V8 XJ Series/XK

DATE 08/00
Amended 12/01

413-S484

Instrument Pack Assembly – CAN Failure – Service Action S484

ILLUSTRATION 2

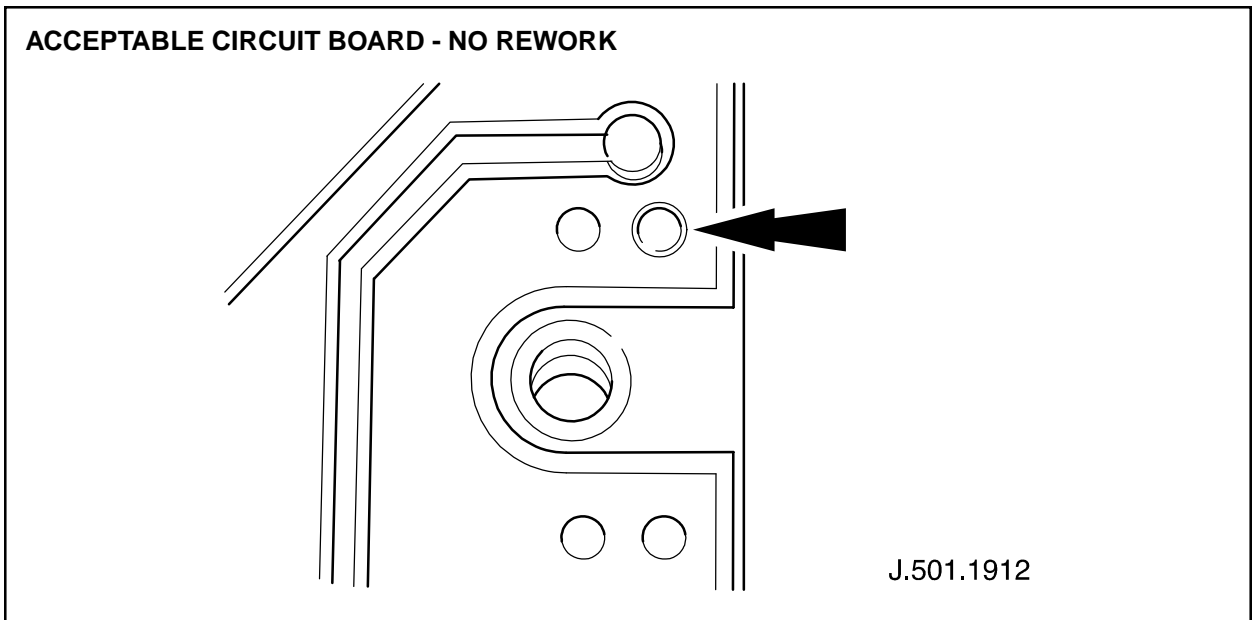
Illustration 2 shows an acceptable circuit board. This board does not require rework.

ILLUSTRATION 3

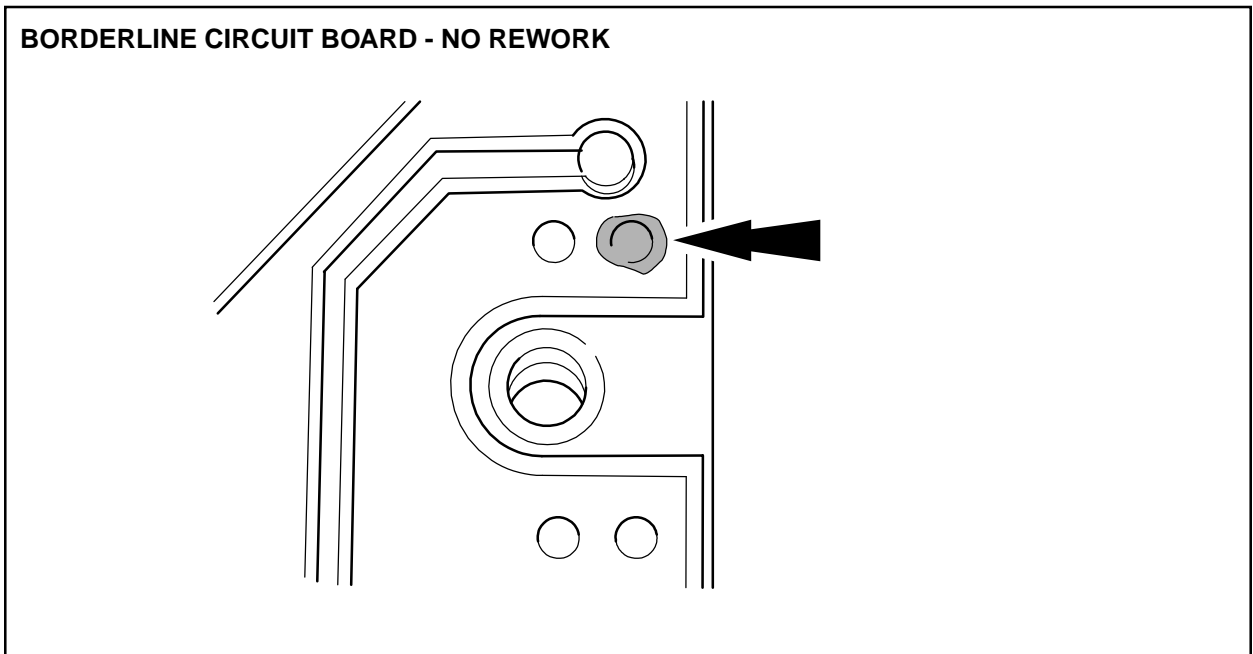
Illustration 3 shows a borderline case. This circuit board does not require rework.

ILLUSTRATION 4

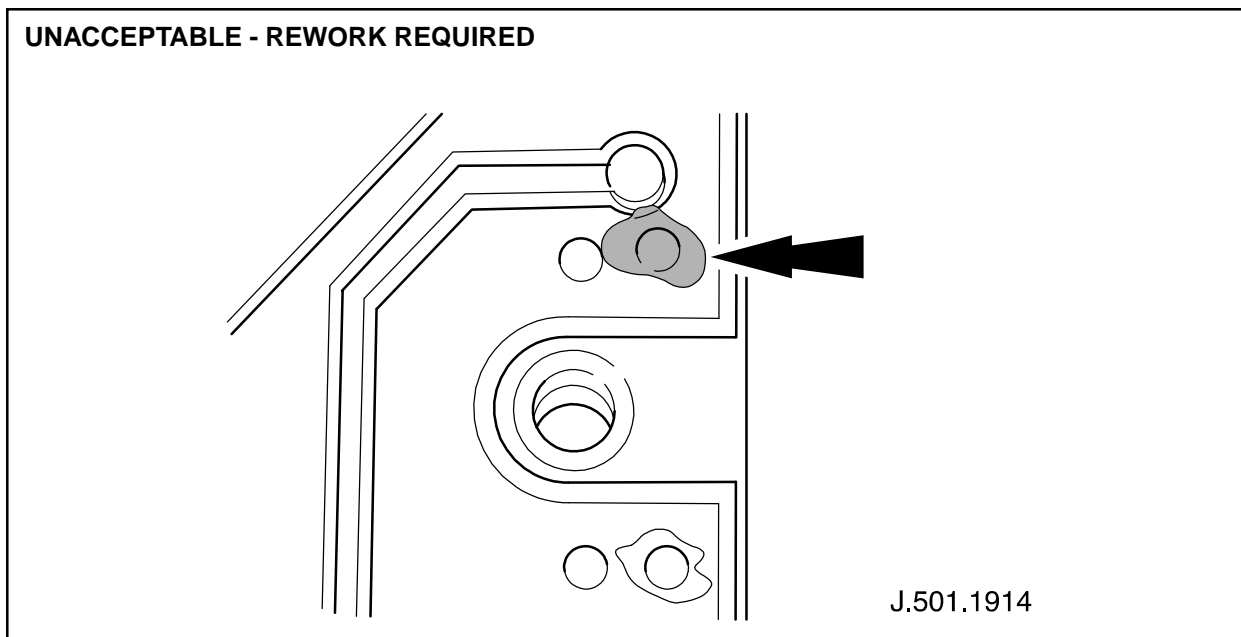
Illustration 4 shows an unacceptable case. This circuit board requires rework

If rework of the solder area is required (Illustration 4) proceed to step 11.

ILLUSTRATION 5

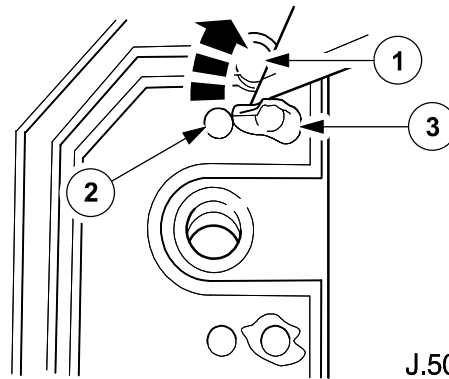
⚠ Caution: Do not use the craft knife in a downward cutting action across the board. This will damage the board. Cut at an angle ensuring that only the solder is cut through. Ensure all traces of cut solder are removed and discarded. Do not leave any solder particles. This could cause further contamination to the board. Do not remove solder from other areas of the circuit board, only those identified in this Service Action.

11. Using a sharp craft knife, raise and fold back any solder that has spread beyond the borderline area, as shown in illustration 5
12. Using a sharp craft knife, cut off the raised solder segments. See illustration 5.
13. Using a continuity meter, check there are no shorts between test point 1 and the two adjacent solder points 2 and 3 as shown in Illustration 5.

Note: Do not test between points 2 and 3 since these are ground points.

⚠ Caution: During the test operation in step 13, if a short is present, repeat solder removal operation.

ILLUSTRATION 6

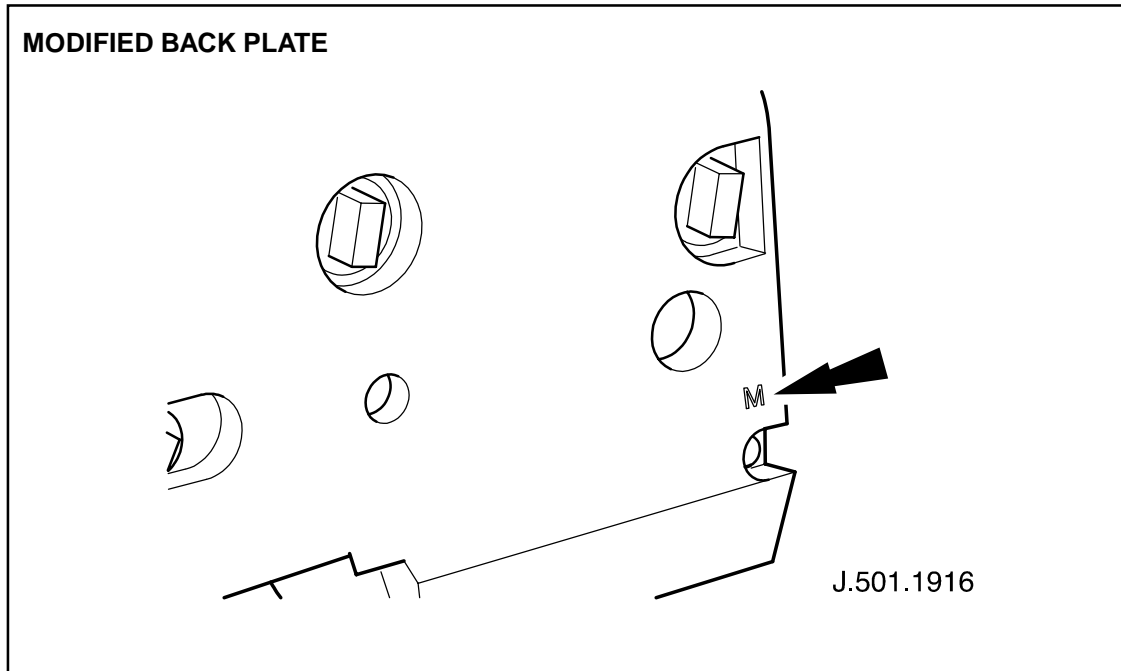
14. Position and seat the new supplied module back plate. (Modified back plate has relieved screw boss).

Note: The supplied modified back plate is identified by an “M” mark on the outer face, this will inform future workshops that the back plate has been replaced (Illustration 6).
